# Access Compliance Report

## Public Rights-of-Way

Intersection ID: 45784	Main Street: CRABAPPLE_TREE_LN	Cross Street: LONG_HILL_DR	Location: W
ADA ID: 429F0532E786	Ramp Type: PerpDiag	Initial Pass/Fail: Fail	Overall Compliance: No
Severity Score: 22.5			
Codes/Mitigation Info/Possible Solution		Field Measurements/Component Compliance

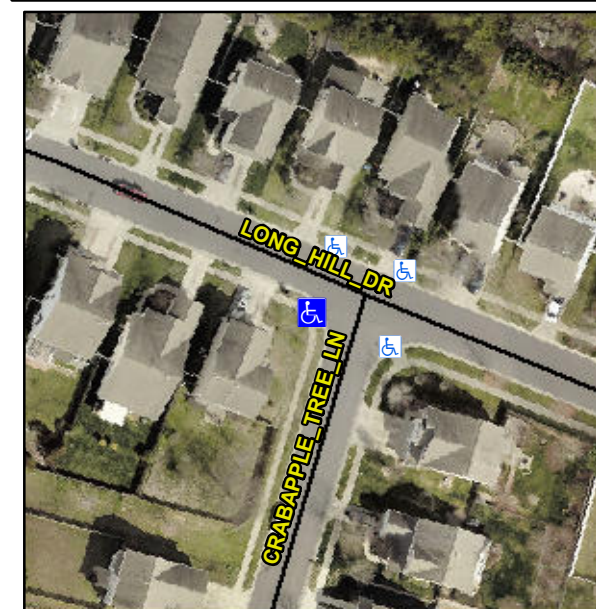
**Not Found, R304.5.1, R304.2.2, R304.5.3**

Compliance	Description	Data	Compliance	Description	Data
N/A	Ramp Length (in)	91.5	No	Ramp Slope (%)	9.3
No	Ramp Width (in)	47.0	No	Ramp XSlope (%)	4.8
N/A	Flare Type LT	N/A	N/A	Flare Type RT	N/A
N/A	Flare Slope LT (%)	N/A	N/A	Flare Slope RT (%)	N/A
N/A	Flare Traversable LT?	N/A	N/A	Flare Traversable RT?	N/A
N/A	Landing Length (in)	N/A	N/A	DWS Provided?	N/A
N/A	Landing Width (in)	N/A	N/A	DWS Contrast?	N/A
N/A	Landing Slope (%)	N/A	N/A	DWS Length (in)	N/A
N/A	Landing X Slope (%)	N/A	N/A	DWS Full Width?	N/A
N/A	Landing Curb? (Y/N)	N/A	N/A	DWS Offset (in)	N/A
N/A	Shared Landing?	N/A			
N/A	Gutter Ponding?	N/A	N/A	Gutter Slope (%)	N/A
N/A	Gutter Lip Ht (in)	N/A	N/A	Gutter X Slope (%)	N/A
N/A	Painted X Walk1?	No	N/A	Painted X Walk2?	No
	X Walk 1 Direction	To SE		X Walk 2 Direction	To NE
N/A	X Walk 1 Width (in)	N/A	N/A	X Walk 2 Width (in)	N/A
	X Walk 1 Slope (%)	4.2		X Walk 2 Slope (%)	4.6
	X Walk 1 X Slope (%)	4.3		X Walk 2 X Slope (%)	1.5

N/A	Ramp inside XWalk1?	N/A	N/A	Ramp inside XWalk2?	N/A
	Road Slope (%)	2.2	N/A	Clear Space?	N/A
	Road X Slope (%)	4.0	N/A	Clear Space to XWalk (in)	N/A
N/A	Any Obstructions?	N/A	N/A	Storm Grate/Utility Hazard?	N/A
	Obstruction Type			Storm Grate/Utility Type	
		N/A			N/A
			Yes	Surface Condition? (G/P)	Good

**Remove & Replace Curb Ramp With Two New Directional Ramps or Equivalent.**
